UNITED STATES PATENT AND TRADEMARK OFFICE

APPLICATION NO.	FILING DATE	FIRST NAMED INVENTOR	ATTORNEY DOCKET NO.	CONFIRMATION NO.
10/608,494	06/30/2003	Gordon Eppen JR.	306-056	8639

Office Action Summary

DETAILED ACTION

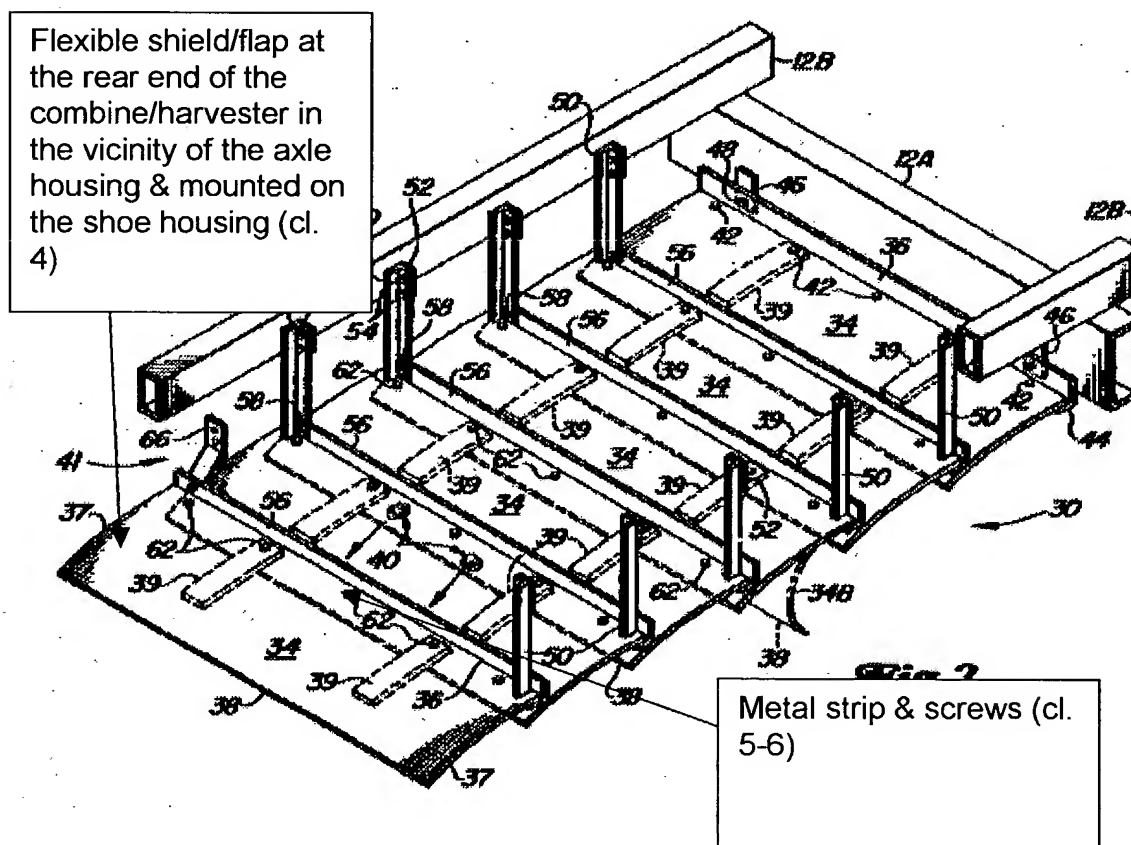
9. Claims 4-6 are rejected under 35 U.S.C. 102(b) as being anticipated by McConnell (5405292).

McConnell discloses and as shown below for greater clarity:

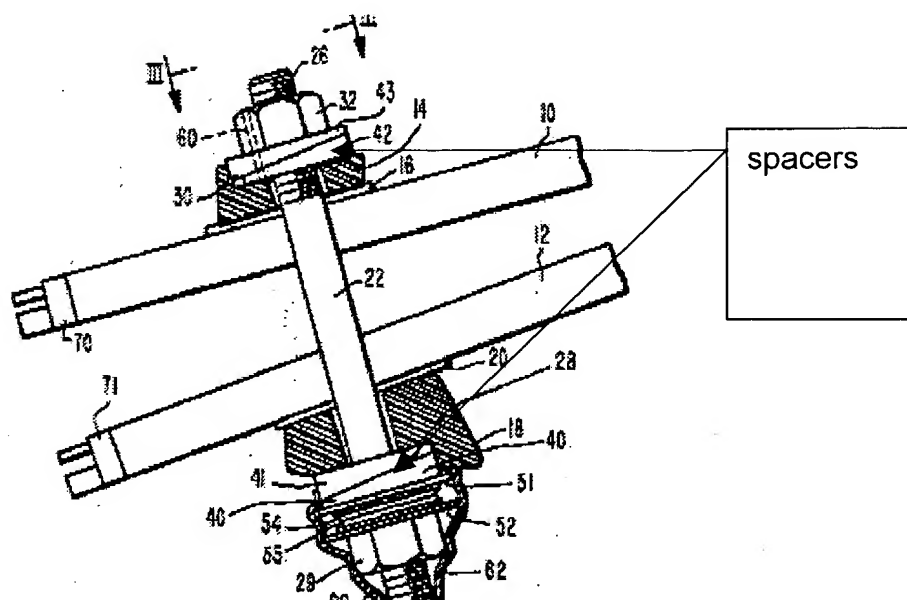
11. Claim(s) 1-3 are rejected under 35 U.S.C. 103(a) as being unpatentable over Applicant's prior art of fig 1, in view of Dailey et al (4415825).

In re claims 1-3, Dailey discloses (as shown below) that it is known in the art to provide spacers, although it has been well known to provide an overwhelming different types of spacers.

It would have been obvious to one having ordinary skill in the art at the time the invention was made to provide the Applicant's prior art of fig 1 with the general teachings in the art of having spacers, in order to minimize slippage between bolts and nuts.
